From: [Pine duBois](#)
To: [Docket_Hearing](#)
Cc: [Lamb, John](#); [Watson, Bruce](#); [Klukan, Brett](#); [David Johnston](#); [Jack Priest](#); [Sean Mullin](#); [John Giarrusso](#)
Subject: [External_Sender] Revised PSDAR and Revised Site-Specific DCE for Pilgrim Nuclear Power Station
Date: Monday, March 04, 2019 5:05:27 PM
Attachments: [JRWA comment Holtec PSDAR.pdf](#)

Docket No. NRC 2018-0279

Pilgrim Nuclear Power Station

PILGRIM WATCH COMMENT DOCKET NO. NRC 2018-0279

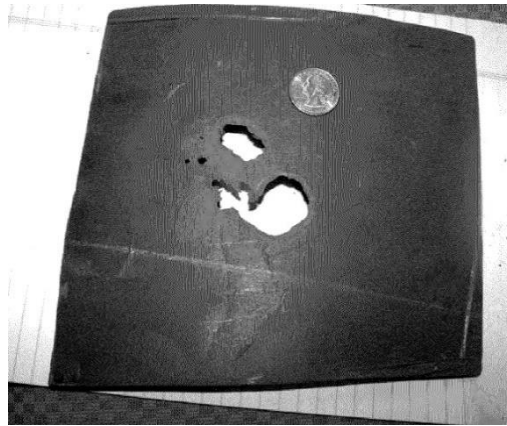
The photograph below shows a hole in one of Pilgrim's buried SSW discharge pipes.³¹ There is every reason to assume that it is not the only one.

Holes such as that shown above leak, and neither Holtec nor the NRC can properly assume that it is the only one. Holtec must be required to conduct a new site assessment to determine the extent of leakage,, i.e., so that “ radiological, regulated, and hazardous wastes are identified, categorized and quantified to support decommissioning and waste management planning “(CDE, p. 14), and to include in its PSDAR and DCE the costs of removing contamination around buried pipes and tanks and a showing that the DTF has sufficient funds to do so.
